## **Technical Service Bulletin**

## MODEL(S) T500, T500e and Speed Scrub 500 Floor Scrubbers

N. America machines manufactured between March 2 - June 16, 2021

## **Friction Disc Removal Instructions:**

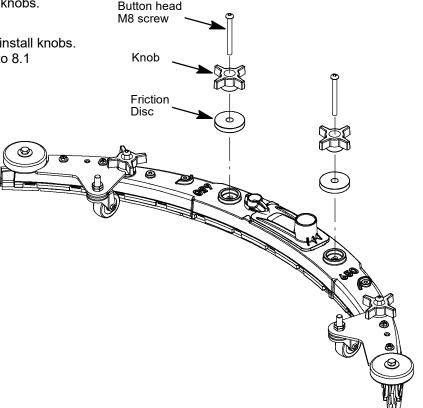
- **SUBJECT:** Squeegee performance. In March, production machines transitioned to utilizing the same squeegee assemblies as the T600 machines. These squeegee assemblies contain two friction discs which are not required on the T500/e and Scrub Scrub 500 models. The extra thickness of the friction discs may affect proper water pickup. The use of these discs may also reduce the break-away force allowing the squeegee to come free from scrubber too easily.
- PURPOSE: To prevent the above condition, remove the two friction discs as described below.
- **NOTES:** Warranty Information: Standard warranty terms apply. New aftermarket replacement squeegee assembly kits without friction discs will be available in the near future.

- 1. Remove the two M8 screws from center knobs.
- 2. Lift off and discard the two friction discs.
- Reapply Loctite to the M8 screws and reinstall knobs. Screw torque range of 6 to 11 N-m (4.4 to 8.1 foot-pounds).
